**City of Portland, Maine – Building or Use Permit Application** 389 Congress Street, 04101, Tel: (207) 874-8703, FAX: 874-8716

Location of Construction: 55 Pelicia Ln (Lot 8 Deering Meadow)		Owner: Jandie Development Corp		Phone: 797-9534		Permit No: <b>990406</b>	
Owner Address: 2 Flintlock Ln Palmyra ME 04106		Lessee/Buyer's Name:		Phone:		Business Name:	
Contractor Name: SAA		Address:		Phone:		Permit Issued: APR 30 1999 CITY OF PORTLAND	
Past Use: Vacant Land		Proposed Use: 1-family dwelling w/ attached garage		COST OF WORK: \$ 50,000		PERMIT FEE: \$ 270.00	
				FIRE DEPT. <input type="checkbox"/> Approved <input type="checkbox"/> Denied		INSPECTION: Use Group <i>A3</i> Type: <i>5B</i> <i>BOCA90</i> Signature: <i>Hoffman</i>	
Proposed Project Description: Construct 26 x 32 cape w/attached 21 x 22 garage				Signature:		Signature: <i>Hoffman</i>	
				PEDESTRIAN ACTIVITIES DISTRICT (P.A.D.)		Zone: CBL: 171-A-048	
				Action: <input type="checkbox"/> Approved <input type="checkbox"/> Approved with Conditions <input type="checkbox"/> Denied		Zoning Approval: <i>OK with conditions</i> <b>Special Zone or Reviews:</b> <input type="checkbox"/> Shoreland <input type="checkbox"/> Wetland

# FELICIA LANE

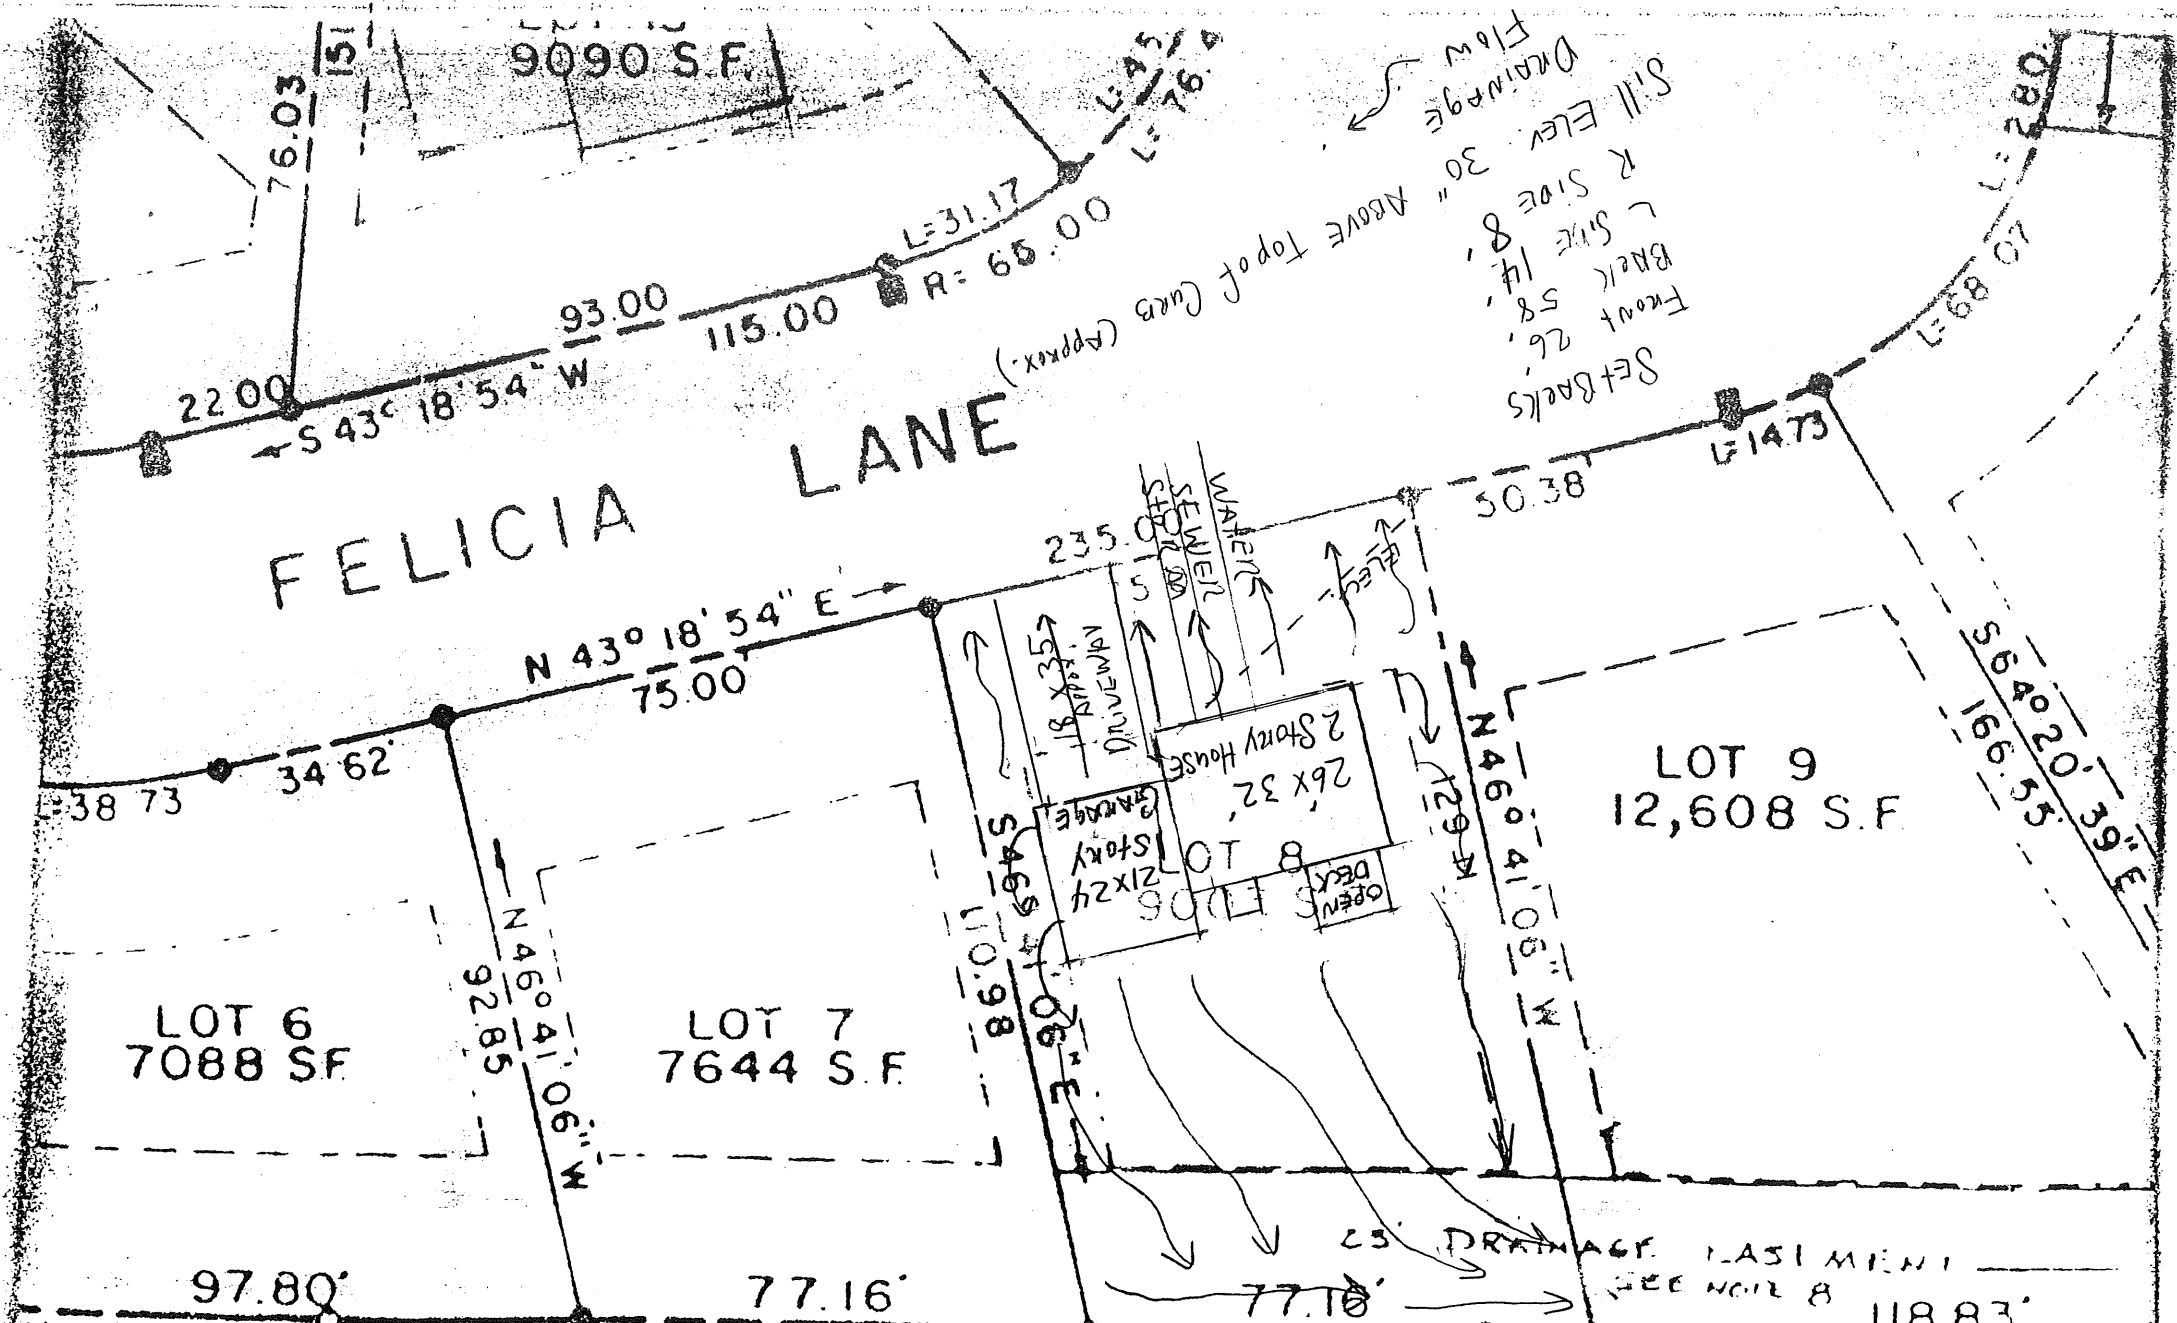
He can reduce on one side (his 14' side) to no more

THAN 8' if for every amount he takes off on that side, he

shall add the same amount to the other side.

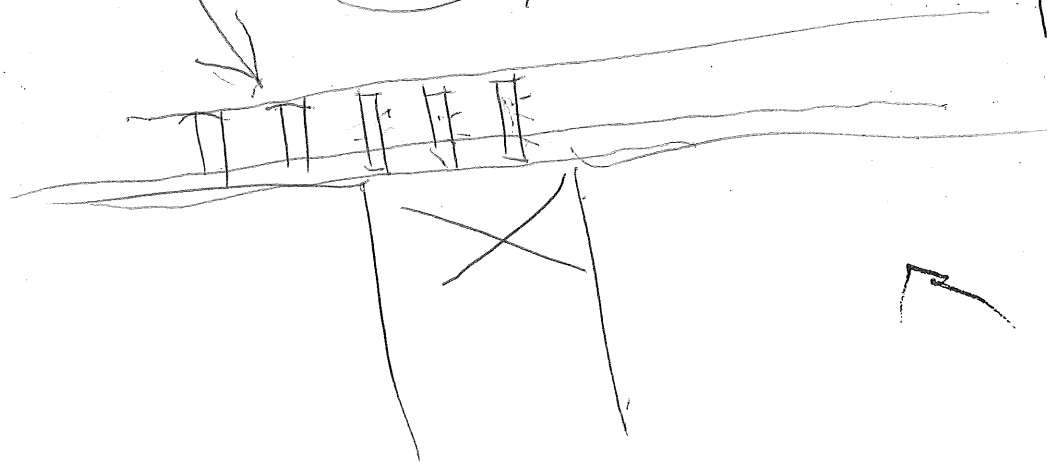
- ① Need ammendment for deck
- ② Garage stairs - need guardrails + handrail
- ③ Ballusters - 1<sup>st</sup> flr stairs - 4<sup>3/8</sup>" spacing
- ④ Deck stairs - treads + risers incorrect
- ⑤ No graspable handrail on deck stairs
- ⑥ Header over bulkhead opening
- ⑦ No riser boards on bsmt stairs (walkway)
- ⑧ Improper guards on bsmt stairs.

1) JVS  
 2) CHECK w/ BOCA  
 3) CONTRACTOR

5  
 NOT DONE YET.

4) TREADS + RISERS

Box SILL / BULK HEADER?

SNOW FENCE FOR BALUSTERS
